ULPOWER AERO ENGINES N.V.

SERVICE BULLETIN

Service Bulletin No. 2012-01

SUBJECT: Alternator fan

picture 1

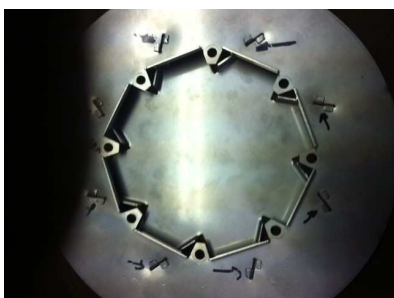
Original the 2 parts of the fan were connected to each other by bended flaps. See picture 1.

However, even this connection can come loose. Because of vibration the bended flaps break. ULPower need to change urgent the design!

Until ULPower release a new design, we strongly advise to weld the 2 parts to each other as showed in picture 3.

picture 2

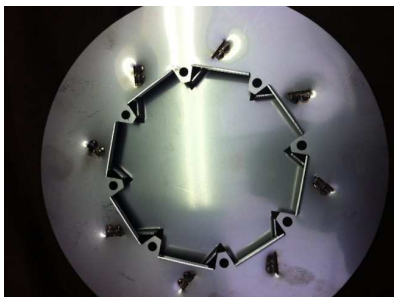
Because the connection can come loose. ULPower redesigns and the two parts are now welded to each other. See picture 2.

If the customer is not capable to weld it, ULPower can deliver a new fan, welded conform picture 3.
